**EB-2016-0105**

**Thunder Bay Hydro Electricity Distribution Inc.**

**Application for electricity distribution rates beginning  
May 1, 2017.**

**AMPCO Compendium**

- a) Below is the corrected Table III-2 Total Year 1 and 10-Year Total Flagged for Action Plan.

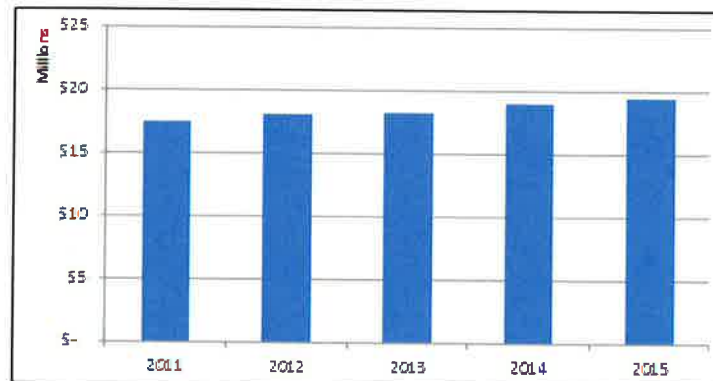
- a) For each asset category please provide a comparison of Table III-2 10 year levelized Flagged for Action Plan in the ACA with TBH's capital expenditure proposals for 2017 through 2021.

- b) Given the ACA is based on 2015 data please explain how 2016 actual capital expenditures are being considered in the response to a).
- c) For each asset category please provide both the quantity of assets TBH has or proposes to replace in 2016 and 2017 and provide a comparison to the first year amount flagged in the ACA action plan. Please comment on any differences.

- a) While preparing the response to this interrogatory TBH discovered an error in Table III-2. Specifically, the spreadsheet used to calculate the 10 year FFAP included an incorrect cell reference. Attached below are the corrections provided by Kinectrics to fix for that error.

TBH believes that its DSP is not affected based on the results of this table as the error only affected the last two years of the 10 year levelized quantities and the DSP only encompasses the first 5 years of levelized planning. Therefore there are no further revisions to be made as a result of the error in this table.

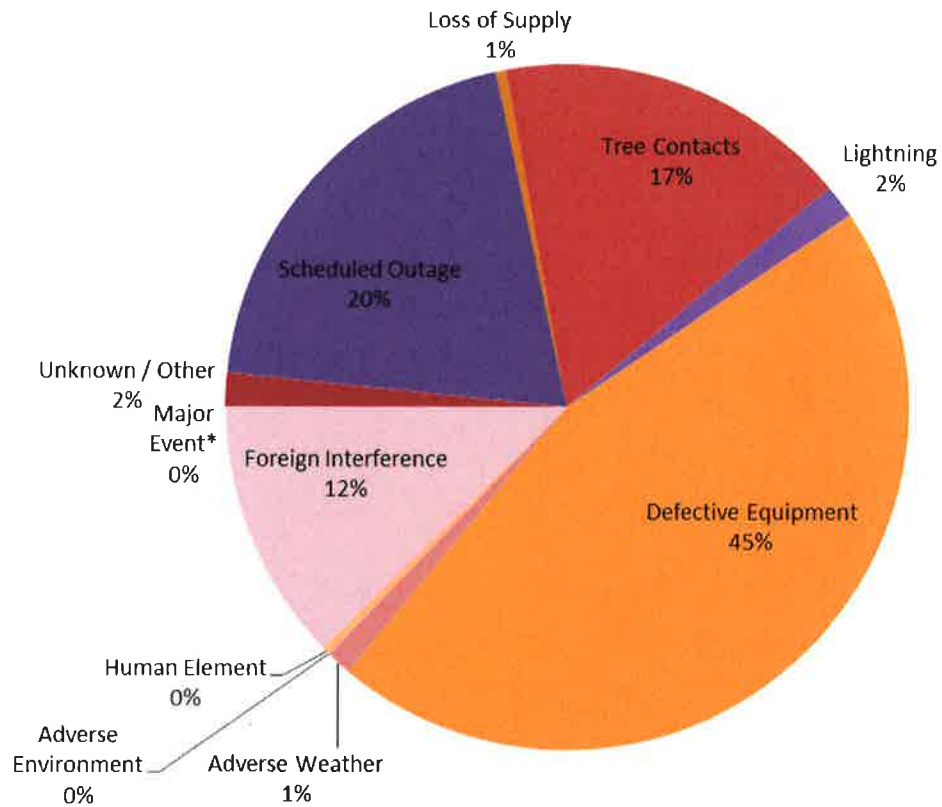
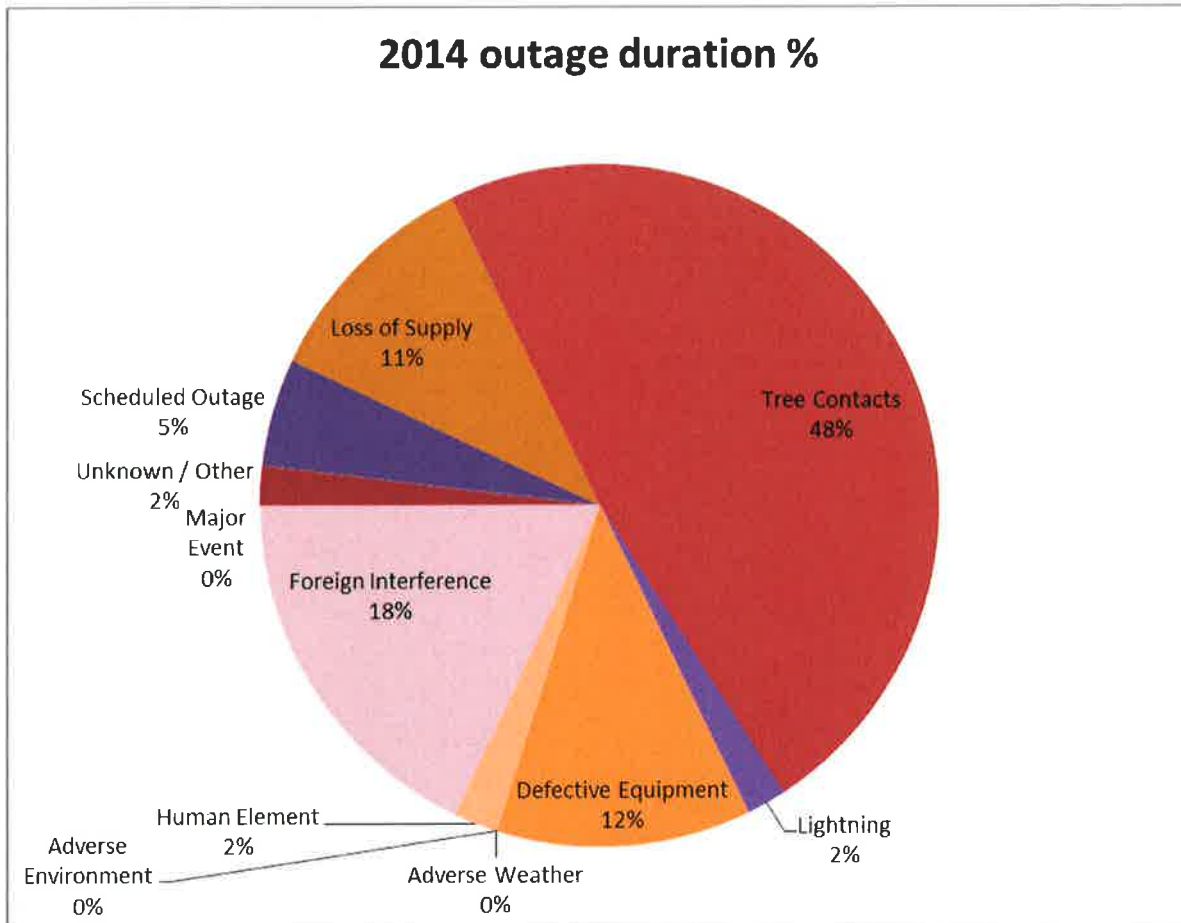
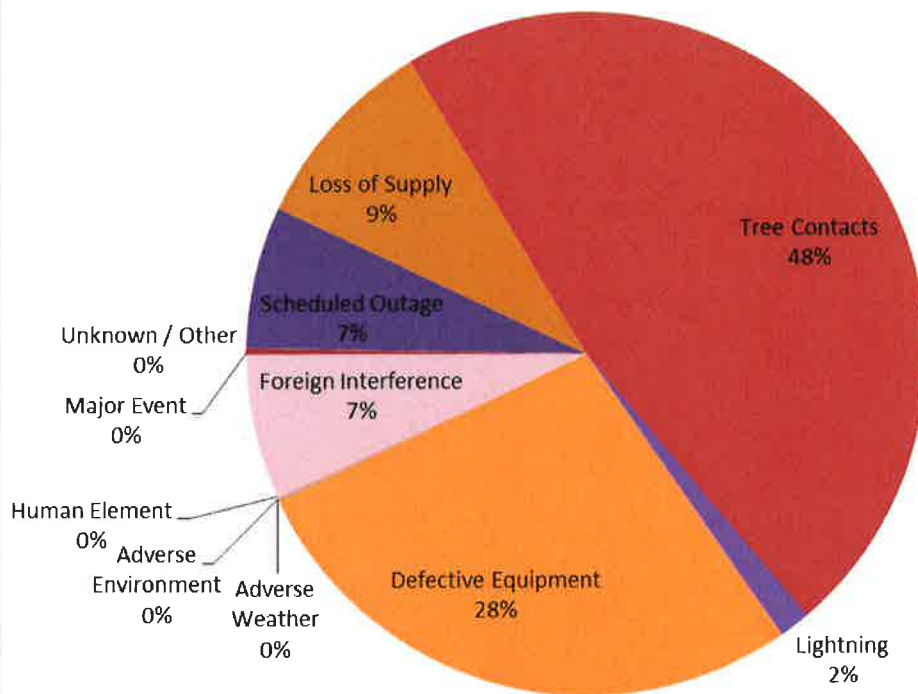
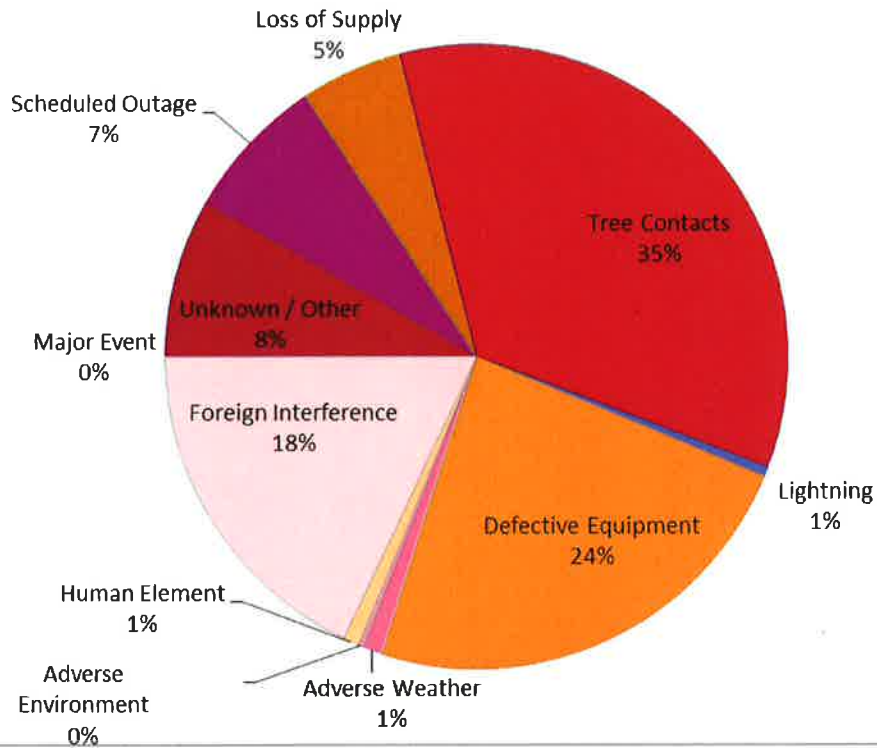
- a) Figure 5.2.3-5 Outage Causes by Duration: Please provide Figure 5.2.3-5 separately for each of the following years: 2012, 2013, 2014, and 2015.
- b) Please provide a Figure that shows the Outage Causes by Duration for 2016.

**Figure 3 – TBHEDI's 10-Year FFAP**

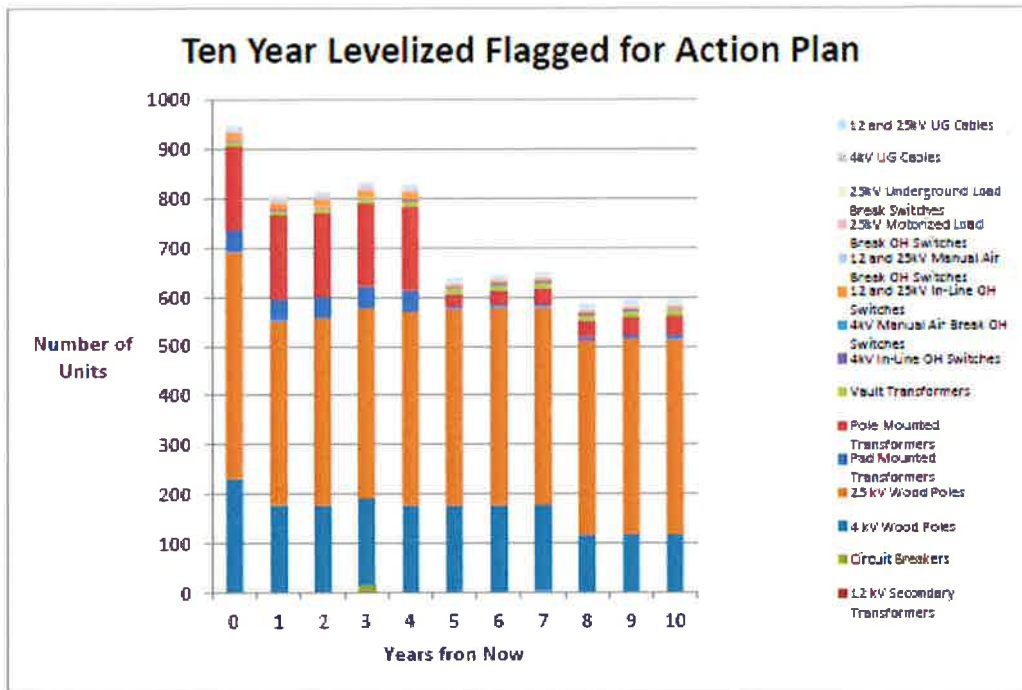
a) Please explain the reasons for the significantly higher number of units flagged for action during the first five years (year 0 to 4) shown in Figure 3, and particularly the number of units in year 0. Please quantify the explanation, to the extent possible.

b) Does the Flagged-for-Action Plan (FFAP) shown in Figure 3 incorporate the asset replacements forecast in the present filing? If not, please provide an updated version of Figure 3 that does incorporate the forecast replacements.

c) What would be the anticipated reliability impacts of implementing a replacement program that was more evenly paced over the planning horizon shown in Figure 3?

d) Please compare the FFAP with historical replacements for the 5 year period immediately prior to year 0 in Figure 3.

e) Please explain the reasons for any significant (>10%) inter-annual unit flagged for action counts over the historical and planned horizons, by asset class.

- d) Please see below the historical replacements for the 5 year period immediately prior to year 0.

- b) The asset replacement forecast in the present rate filing incorporates FFAP is an input in representing condition driven replacement needs along with other drivers (see response to ER-Staff-79 a)) and not the other way around.
- c) Please see our response to ER-Staff-80 b)
- e) FFAP was developed for the first time in 2016 and represents condition based only replacement requirements. Historical replacements represent not only condition based replacements but also replacements for other reasons and, thus, should not be compared to the FFAP in the ACA.

Figure 5.3.2-1 - Kinectrics ACA Wood Pole Health

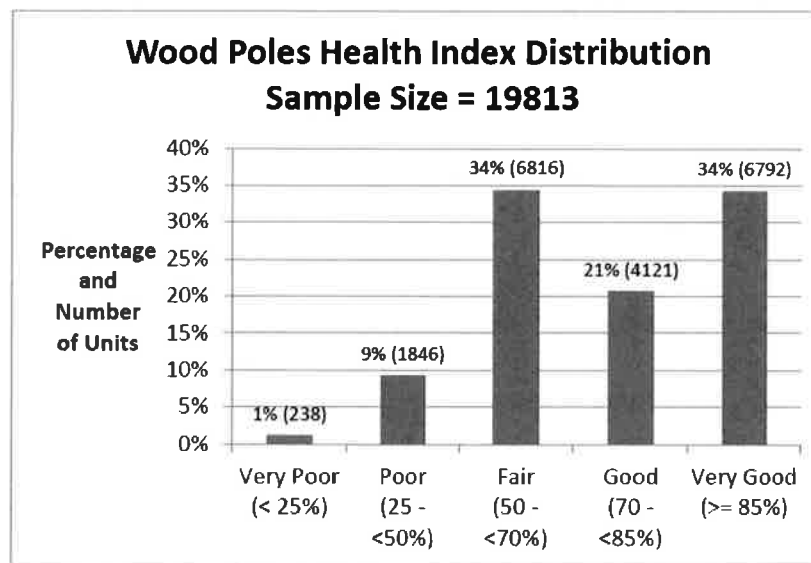
Please reconcile the wood pole health index distribution with Thunder Bay Hydro's 700 pole per year replacement target.

The health index distribution cannot be reconciled with the 700 pole per year target. The 700 pole per year replacement target was developed utilizing average age of the population (see response to 2-Staff-39(b) ); whereas the health index is a quantitative composite measure of an assets condition based on available condition data, (testing, inspections, utilization, expert opinion, age, etc.) of which age is one of several factors considered in the calculation. Thunder Bay Hydro is moving away from an age based asset replacement strategy to an asset condition based strategy and as a result the quantities of poles that are targeted for replacement are as specified in response 2-AMPCO-15.
